**JAGUAR LAND ROVER, HALEWOOD
BODY IN WHITE SOUTH EXTENSION**

**DRAINAGE TECHNICAL NOTE IN REPOSE TO LLFA
COMMENTS FOR PLANNING REF:22/00458/FUL**

Report Title: Drainage Technical Note in Response to LLFA Comments for Planning Ref: 22/00458/FUL

Report Reference: JLR-RDG-00-ZZ-RP-C-0001

TITLE:
PROPOSED DRAINAGE GA
SHEET 1 OF 2

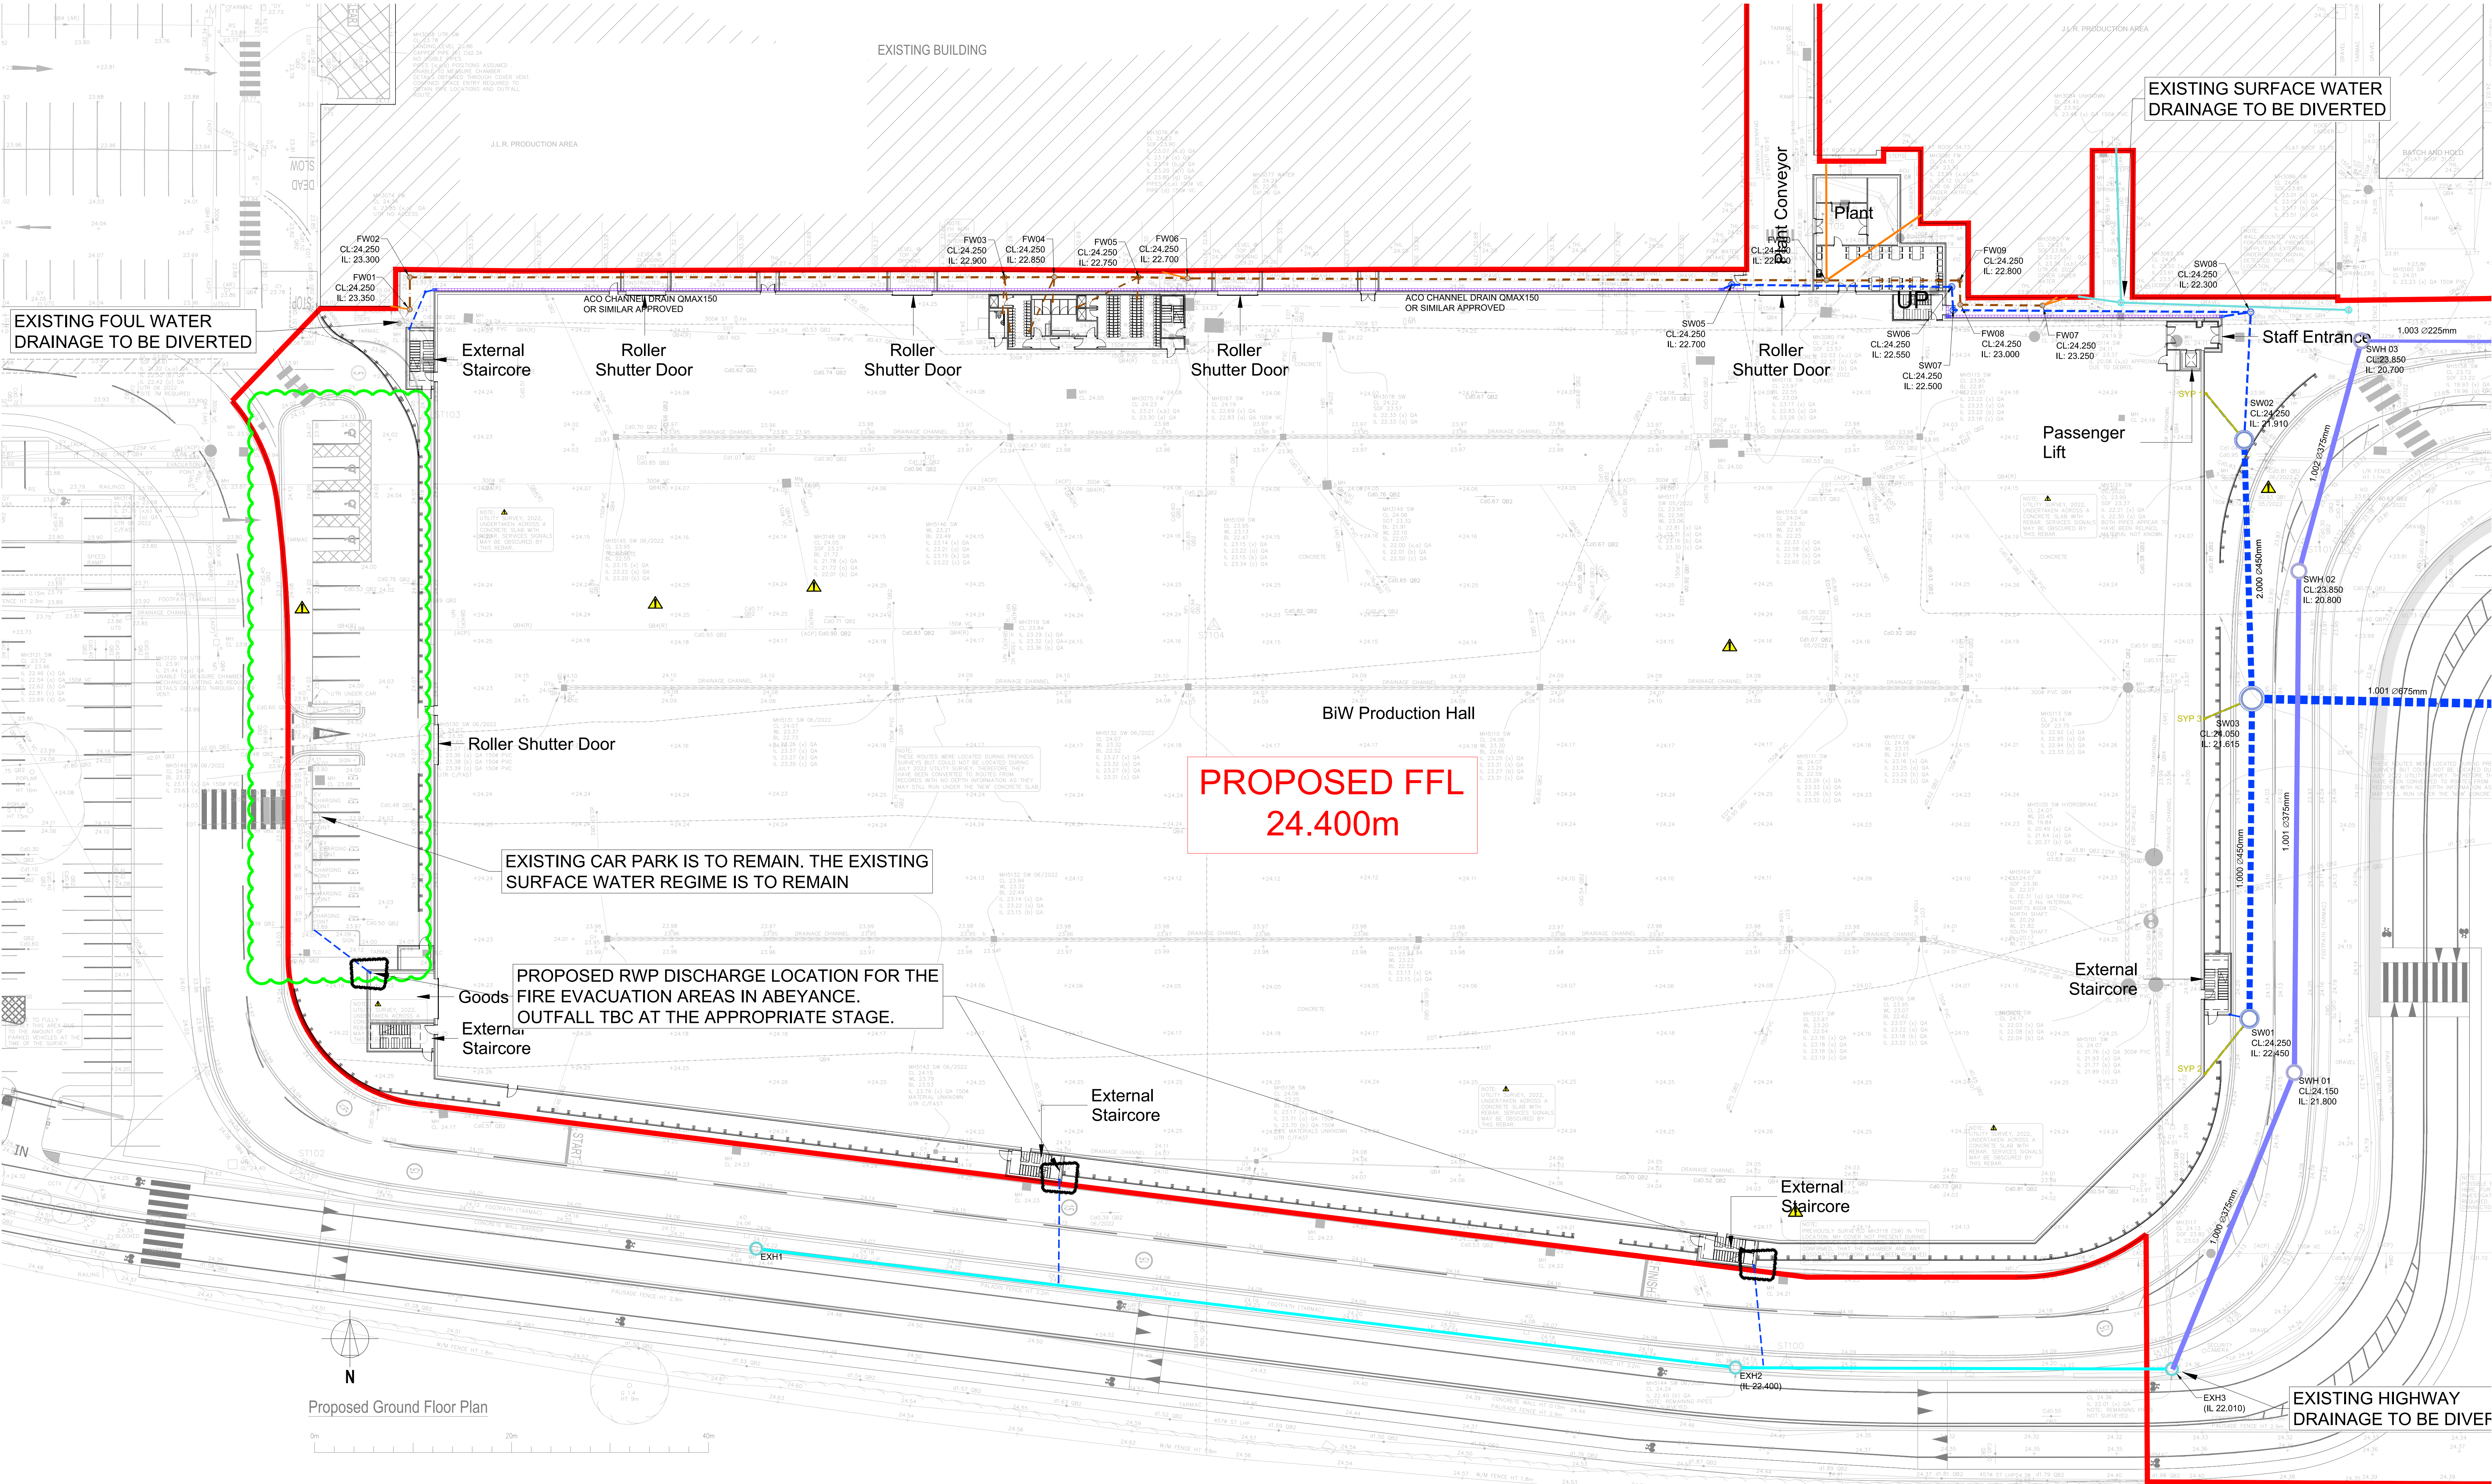
LLFA Comments	Ridge Response
The existing drainage system has been surveyed but no explanation of its features, outfall(s) and how surface water is being managed have been provided. It would be required to demonstrate that which part of the existing drainage system (including network pipes and outfall(s)) will be remained, diverted, or demolished.	Additional plan has now been provided to show the existing private surface water drains and existing private foul water drains. The Existing Drainage and Proposed Abandonment plan and the Proposed Drainage GA plans have been included within Appendix A. Proposed Abandonment plan highlights the existing private SW drains that are to be abandoned as they are not in operation and are not taking any flows. The Proposed Drainage GA plan highlights the proposed diversion of the existing drains. These diversions are essential as parts of the existing drainage system are located underneath the proposed building footprint. It is not feasible to keep the existing drains in place due to possible damage from the proposed building foundations.

Evidence and justification that in selecting drainage features for post-development situation, the surface water drainage discharge hierarchy has been followed. Any drainage strategy proposal should clearly demonstrate how the movement down the hierarchy has been considered and that the selection of the most appropriate set of SuDS techniques has taken into account the site geological and topographical characteristics. To assess the feasibility of infiltration techniques as part of the proposed drainage strategy, evidence must be provided to show that a suitable number of soakaway tests have been completed across the whole site within different geology and to a suitable depth (i.e. a similar depth to the proposed infiltration devices). The tests should be completed according to the BRE 365 method and their results should be submitted with the full application. As part of infiltration tests, an assessment of groundwater levels and its fluctuations on the site will be required.	SuDS Hierarchal Approach has been considered for this scheme and had been explained in Drainage Technical Note 'JLR-RDG-00-ZZ-RP-C-0001'. Infiltration to Ground – No – According to the Ground Investigation report the site is underlain by made ground (up to 1.40m bgl) overlying firm sandy gravelly clay (up to 20m bgl), with groundwater recorded at depths ranging from 1.2m and 6.0m bgl. Due to the cohesive clay deposits which have low permeability and shallow groundwater levels, infiltration is not feasible at the site. Connection to Watercourse – No – An existing local watercourse is located approximately 700m east of the site boundary. Due to the proximity of the watercourse, this approach is not feasible. Connection to Surface Water Sewer – Yes – located at or near to the proposed development there are several private surface water drains. The existing site currently discharges into a private SW drain

A timetable for implementation of the drainage works including an assessment of any phasing of the development if applies.	This is to be confirmed and provided once a contractor has been assigned.
An updated detailed drainage scheme plan will be required in compliance with the above points. The Plan will be required showing the layout of the proposed drainage network, post development impermeable area, post development catchment areas to each SUD feature, SUDs features adopted for interception of first 5mm of rainfalls, the location of the storage within the proposed development, connection points and how these relate to the submitted calculations, including any chamber, pipe numbers, direction of flow, invert and cover levels, gradients diameters, dimensions finished floor levels and access road levels.	The Proposed Drainage GA plan, Manhole Schedule, Existing and Proposed Impermeable Area Plans, Flood Exceedance Plan and A Drainage Maintenance Schedule have been updated. These plans are attached within Appendix A. SuD's features such as silt traps and catchpit manholes have been updated and noted on the Manhole Schedule. Drainage Channels and Siphonic Drainage have been implemented into the drainage design to intercept the rainfall on the roof and hardstanding footway areas. It is important to note that the existing car park SW regime is to remain as is, where currently series of channel drainage intercept the rainfall and the SW is discharged west of the site. No works are proposed for the existing car park area.

TITLE:
FLOOD EXCEEDANCE PLAN

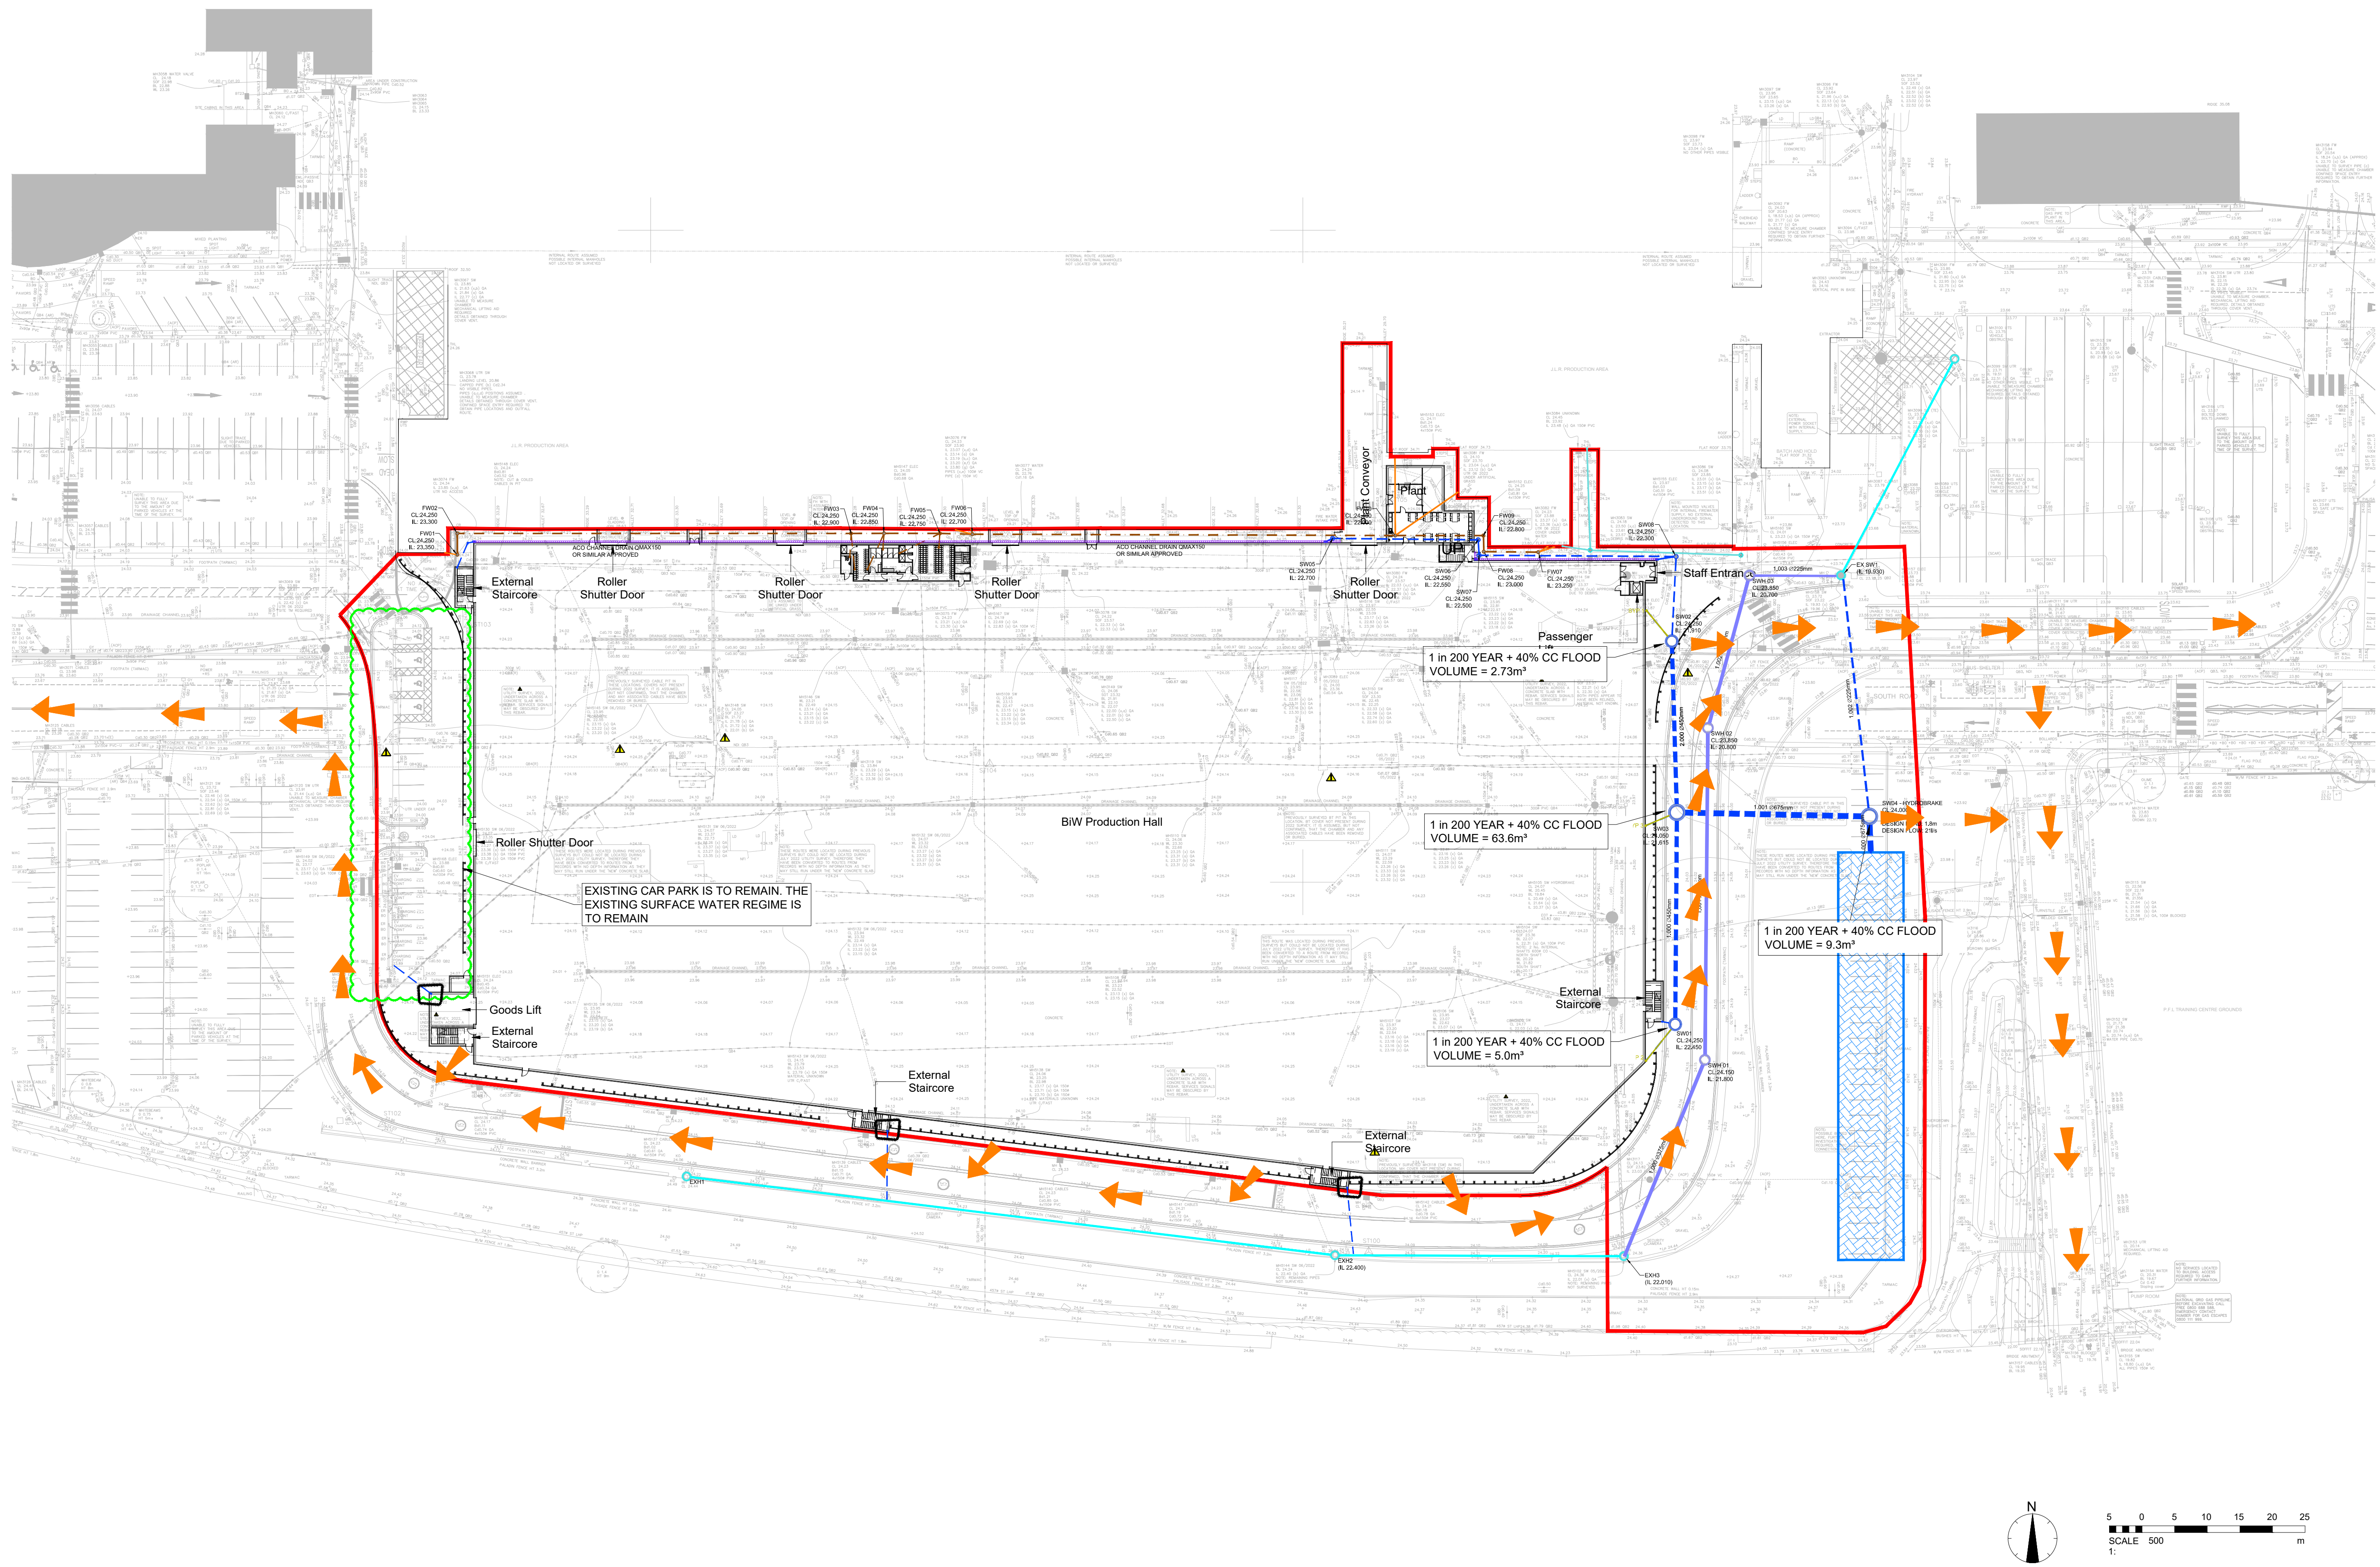
An evaluation of impact of potential failure of the drainage system should be provided. The risk assessment should include for blockage of pipes, blockage of outlet structures and risk of impediments across planned flood routing paths. The drainage design should be supported by a designer's risk assessment that identifies key points of failure of the system and what means have been considered to limit risk of failure. This will also inform the maintenance plan with regards to corrective actions needed should a failure occurs.	A Designers Risk Assessment has been attached within Appendix A.
Construction details of the proposed drainage features (e.g. attenuation tanks, manholes and oil separator) will be required. A demonstration of construction integrity of the proposed SUDS features (e.g. attenuation tank and oil separator) given heavy vehicles traffics and manoeuvring will also be required.	Proposed Drainage Details have been attached within Appendix A.

The proposed roof is to have a semi-gloss paint finish with no metal cladding being exposed. As such, pollution from metals is very low to non-existent. Therefore, no SuDS measures are to be implemented for pollution from Metals. Hydrocarbons for the proposed development is non-existent as there are no proposed car parking areas discharging into the proposed SW system. Therefore, no SuDS measures are to be implemented for pollution from Hydrocarbons.
Exceedance routes of surface water should be provided for the post development situation. It is recommended that based on the exceedance routes and flow depth produced, finished floor levels for proposed building, access roads and car parking to be set. A 1 in 200 years plus 40% event would normally be considered as the exceedance event. It is expected that manholes surcharged during such an event to be identified, and volume and maximum depth of flood water and where the flood water pools or flows to be determined.	The Flood Exceedance Plan provided has been updated to the LLFA comments, this plan is attached within the Appendix A. The updated Flood Exceedance Plan now shows the Flood Volume up to the 1 in 200 year plus 40% CC storm event. Arrows have been shown on the plan to indicate the flow route for flood exceedance runoff. It is anticipated that the SW flow route is to stay within the private highway in between the kerbs. The topography indicates the private highway levels falling from the south east to the north east. Also, a copy of the hydraulic results for the Flood Exceedance has been attached within Appendix B.
